Form 3160-5
(June 2015)UNITED STATES
DEPARTMENT OF THE INTERIOR
BUREAU OF LAND MANAGEMENTFORM APPROVED
OMB No. 1004-0137
Expires: January 31, 2018**SUNDRY NOTICES AND REPORTS ON WELLS**
Do not use this form for proposals to drill or to re-enter an abandoned well. Use Form 3160-3 (APD) for such proposals.

Enduring Resources IV LLC requests to plug and abandon the BETTIN ON BISTI 30 001 per the attached procedure, current and proposed wellbore diagram and reclamation plan.

Enduring Resources Plug & Abandon Procedure May 21, 2019

Re: Permanent Abandonment
Well: Bettin on Bisti 30 001

Bettin on Bisti 30 #1
Proposed P&A
Bisti Lower Gallup
SEC 30, T25N, R11W
API 30-045-27122
Procedure Date: 5/21/2019

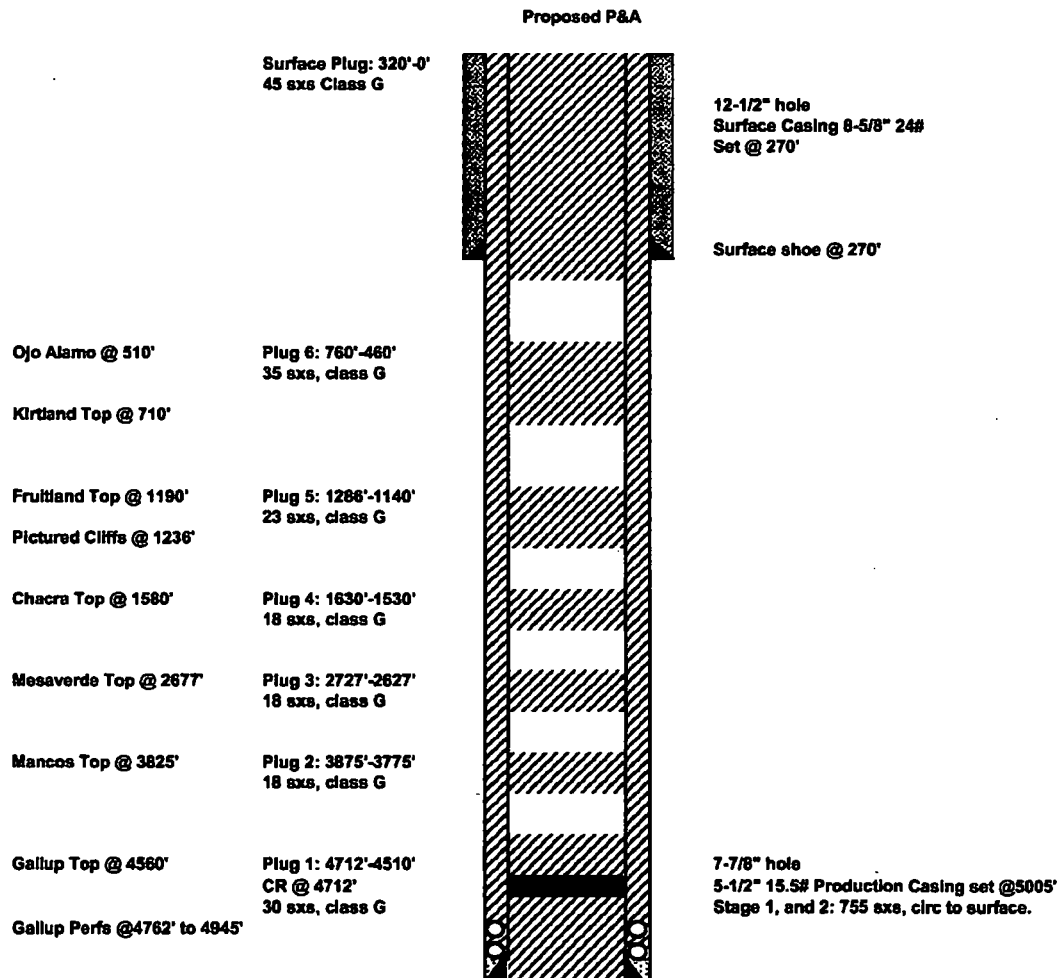
1. Plugging operations authorized are subject to the attached "General Requirements for Permanent Abandonment of Wells on Federal and Indian Lease."
2. Farmington Office is to be notified at least 24 hours before the plugging operations commence (505) 564-7750.
3. If casing fails pressure test, CBL required after setting CR from 4670' to surface to confirm cement. Submit electronic copy of the log for verification to the following addresses: jkillina@blm.gov and Brandon.Powell@state.nm.us . Based on CBL results inside/outside plugs and volumes will be adjusted accordingly. Please review the General Requirements document to ensure volumes meet required excess inside and outside casing.
4. Add additional volume to plug #6 to ensure 50' excess (approx. 41 sx total)
